Proposed New Section 207.2 of the ISO Rules, *Gross Minimum Procurement Volume*

Date of Request for Comment: November 28, 2018
Period of Comment: November 28, 2018 through December 13, 2018

2017 Calibration Draft – Results

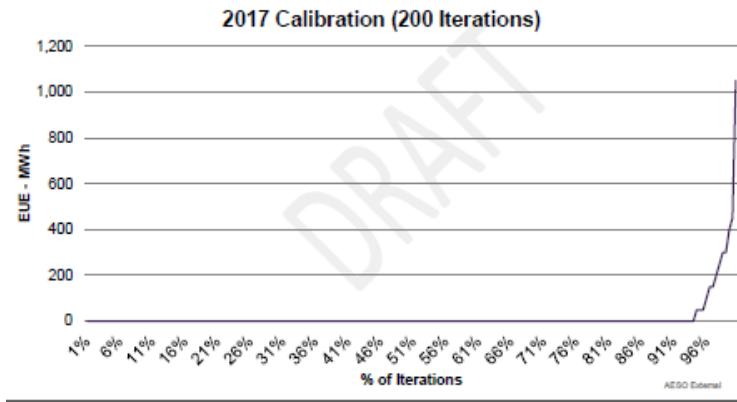
- In 6% of the runs the models produced positive unserved energy
- The outage draw with the poorest reliability showed 1,050 MWh of EUE

The CWG notes that on both slides, the AESO made the previously explained error of mislabeling UE as EUE. This error was identified to the AESO in an industry wide presentation of the material on July 27, 2018.

The CWG also notes that Table 2 in Attachment 1 to Section 207.2 is effectively an update of the table reproduced directly above, labelled “2017 Calibration – Set Up”. Accordingly, the CWG has assumed that the second slide, also reproduced directly above, labelled “2017 Calibration Draft – Results” can be used to assess the appropriateness of Table 2 and Table 3 in Attachment 1 to Section 207.2.

The CWG notes that, based on the shape of the distribution of UE in the 2017 Calibration Draft – Results, reproduced above, scenarios under which UE occurs are very rare.
